Access Compliance Report Public Rights-of-Way (Curb Ramps)

Main Street: ANDORA_DR Cross Street: FAIRHOPE_DR Location: N

ADA ID: RPAT210921082007 Ramp Type: Type 4 - Parallel Initial Pass/Fail: Pass Overall Compliance: No Severity Score: 9

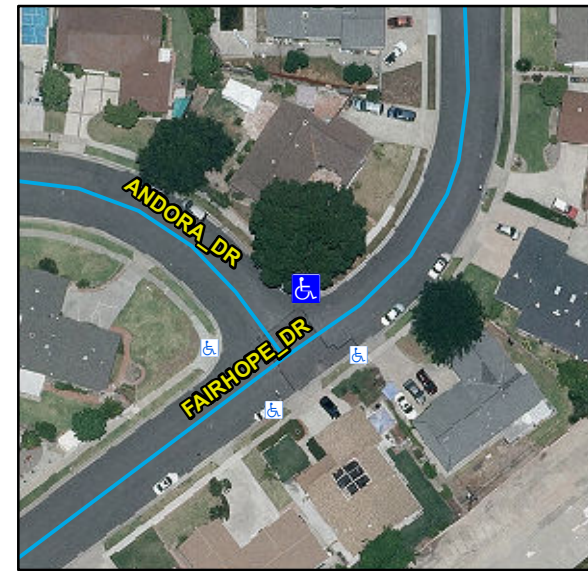
Remove & Replace Landing. Remove & Replace Gutter.

R304.2.1, R304.5.4, STD 1115
